Please accept the following comments and questions about the **Scioto Darby Preserve Commercial Development Type 3 Stormwater Variance REVISED Request (SCIOTO DARBY EXECUTIVE Court)**...

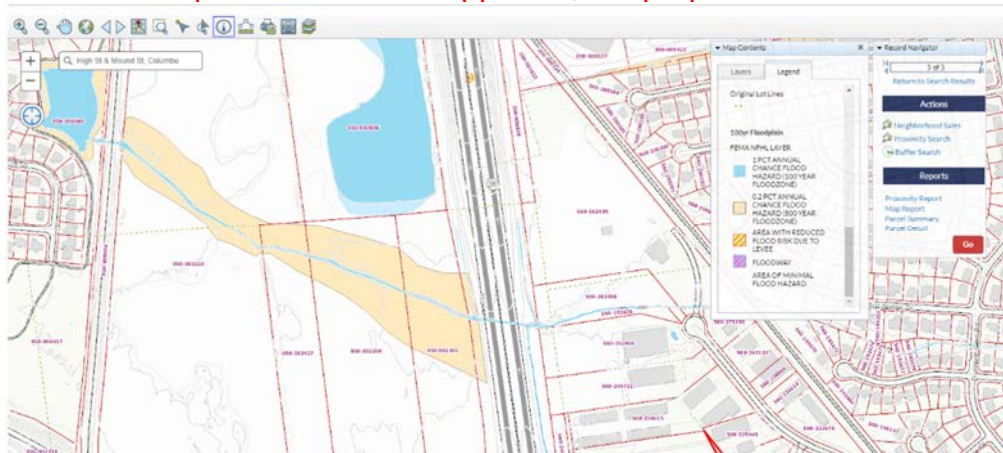
11. This tributary is an unnamed tributary to Griggs Reservoir which is the Drinking water source for over 2 million people. Will there be any chemicals stored on this site that may be of concern if flooding occurs? **This issue is outside of the subject SWDM variance purview. Per the applicant, the proposed use is an office building.**

12. This tributary, east of I-270 has not been mapped by FEMA but appears to be part of the 500 year floodplain for this stream, as shown by the canary shading west of I-270. Again, I am concerned about potential flooding and any chemicals that may be stored on this site. Will any chemicals be stored on site?? **This issue is outside of the subject SWDM variance purview. The City Code and the SWDM only**

regulate 100-year flood. The project site is located outside of the 100-year floodplain.
